California Regional Water Quality Control Board

March 11, 2003

NOTICE OF VIOLATION; STORM WATER PERMITTING REQUIREMENTS; GOLDIE LANE PROPERTY; SANTA MARGARITA; SAN LUIS OBISPO COUNTY; WDID# 3 40S319357

Photo 1 – Eroded hillside.

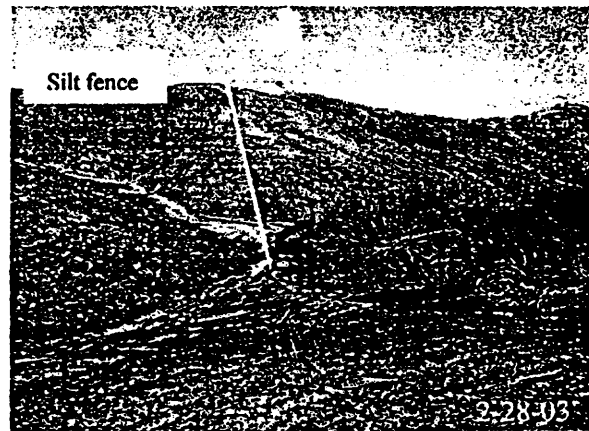
On February 28, 2003, Ryan Lodge and Jennifer Bitting of my staff inspected the Goldie Lane Property and found it in violation of the General Construction Storm Water Permit (Permit). While on site, Regional Board staff observed widespread erosion, and overwhelmed sediment control BMPs (Photos 1, 2). The nearby Huerhuero Creek and a nearby-unnamed creek are tributary to the Salinas River, which is currently listed on the Federal and Regional Board 303(d) List of Impaired Water Bodies for excess silt and sediment.

You have failed to implement a SWPPP and implement erosion control as required by the Permit. You are required to stabilize all inactive disturbed slopes and stockpiles at the site, including site access roads. You are also required to submit a complete updated signed SWPPP to this office by March 21, 2003. The SWPPP shall include a schedule of BMP installation.
